PART II, PORTION, ROOF

FIRST BANK OF THE UNITED STATES

INDEPENDENCE NATIONAL HISTORICAL PARK

Subject: Historic Structures Report, Part II (Portion),
First Bank of the United States, Independence

ROOF PLAN

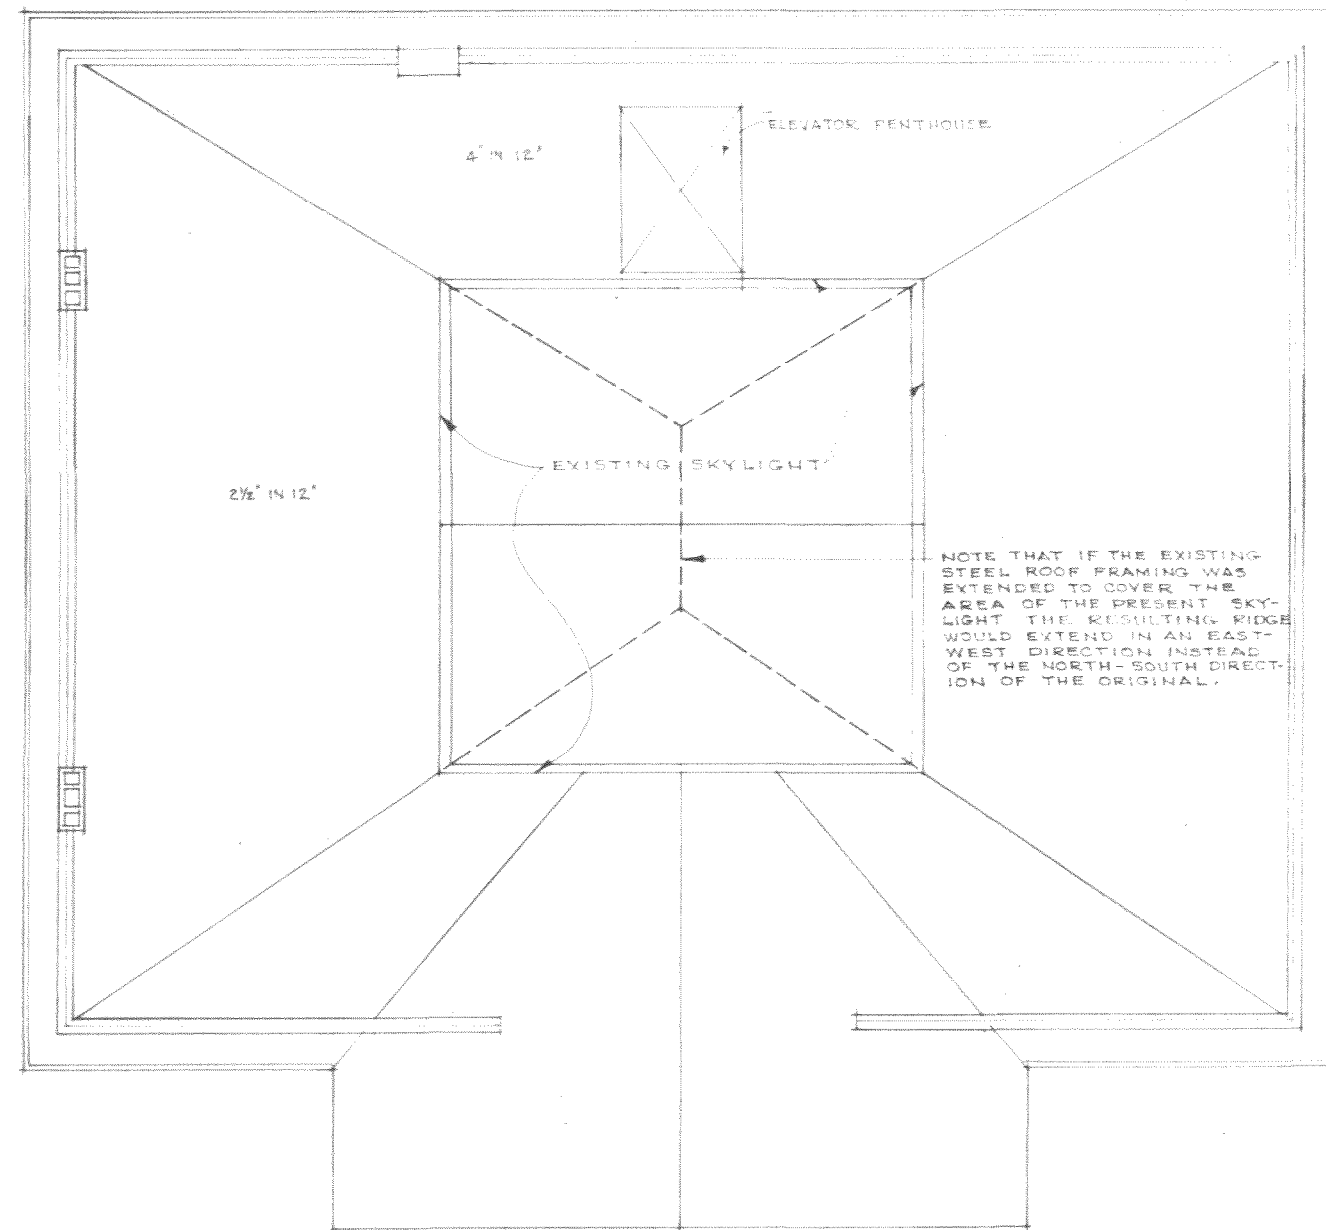
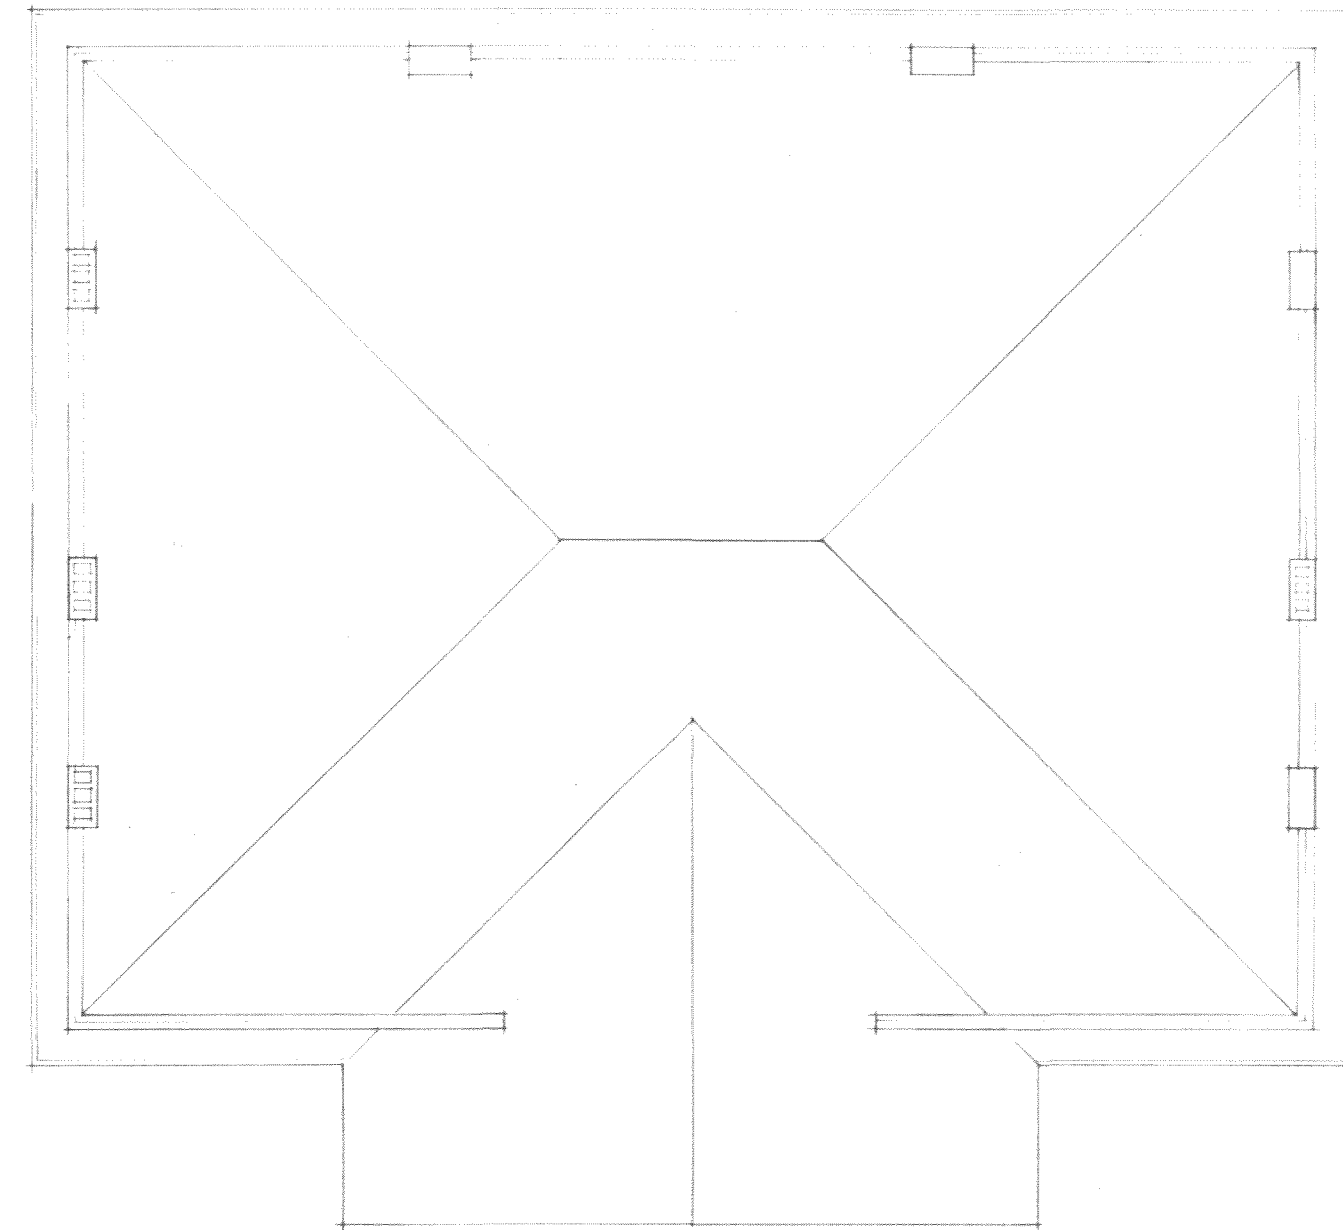
The current project for stabilization of the roof is for the removal of the glass skylight over the rotunda dome and the extension of the existing roof structure to cover the skylight area. In this plan, the glass dome below would be artificially lighted by the placement of fluorescent tubes under the extended roof.

As has been noted, the extension of the existing roof structure would result in a roof shape that would be architecturally awkward and not a restoration of the original roof lines. The extension of the existing structural steel framing would produce a short ridge on a 90° angle from the original, due to the two different roof slopes. The 1901 roof was formed in this manner so as to produce a thirty-five foot square base to hold the glass skylight. This is more readily understood by the explanation that the building is a rectangle in shape and the skylight a square. In order to have the roof of the rectangle meet the square equally on all sides, two sides of the rectangle would have to be more sharply pitched than the other to meet the condition. An extension of the two pitches would result in the ridge of the hip roof running on an east-west axis instead of the original (and logical) north-south axis.

If this work were done, the entire roof would have to be removed at a later date in order to restore the originally designed hip.

1. The repair of the existing glass skylight to make it watertight until the roof restoration could be done.
2. The removal of the glass skylight and the extension of the present steel framing to cover the skylight area (see sketch No. 1).

A false roof to be erected over the existing north and south slopes at a four inch pitch, matching the east and west slopes. The resulting ridge line would then follow the original. The present steel roof structure is sound and the weight of the false roof structure should not affect it. Under this scheme the elevator penthouse could remain until the whole roof is covered with copper and the features such as the balustrades, cornices and chimneys are restored (see sketch No. 1).

The interested divisions have reviewed the subject report and concur with the recommendations stated in Carlisle Crouch's December 2 memorandum, particularly that Alternative #2, temporary repair of the skylight, should be the course of action adopted. I have approved the report this date.

Please note, that of the four alternatives listed on pp. 1 and 3 of the Architectural Data Section of the report for correcting the deterioration of the existing skylight, Alternative #2, temporary repair of the skylight, is recommended by the Park, the EODC, and this office.

SK-1

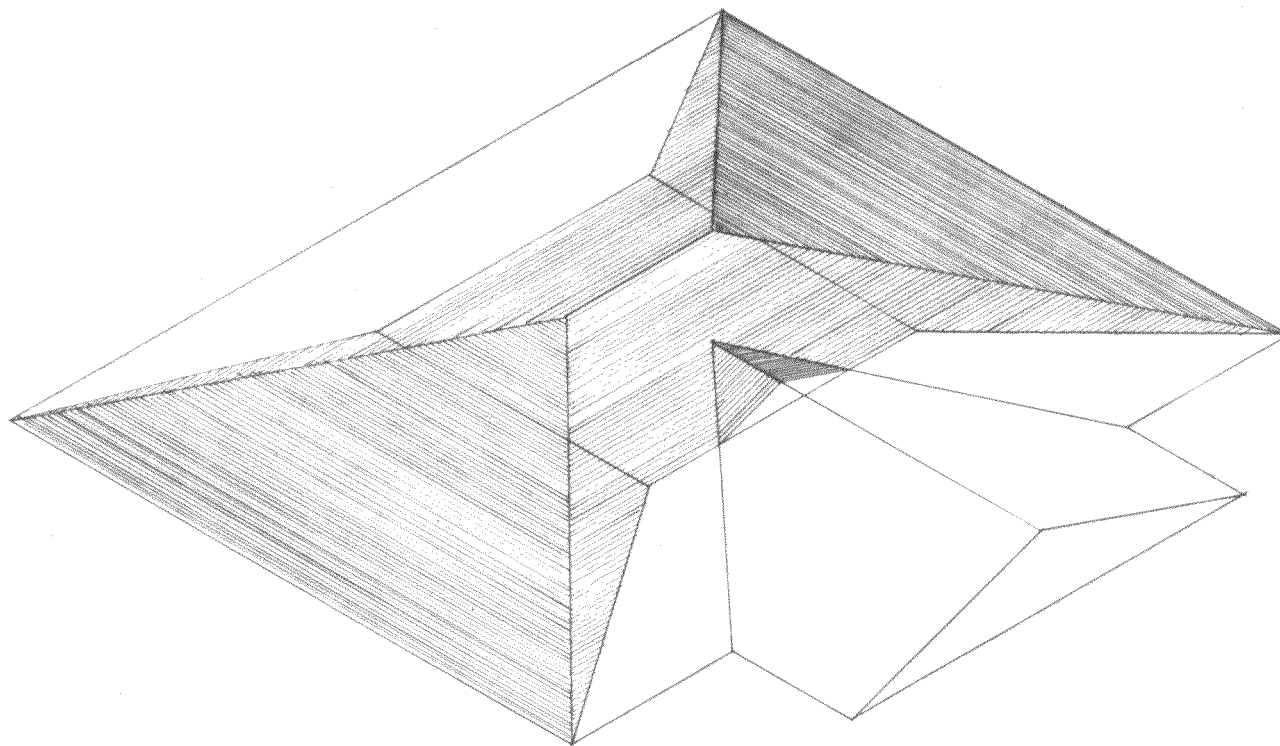
ISOMETRIC SKETCH SHOWING AREAS
OF FALSE ROOF OVER EXISTING ROOF
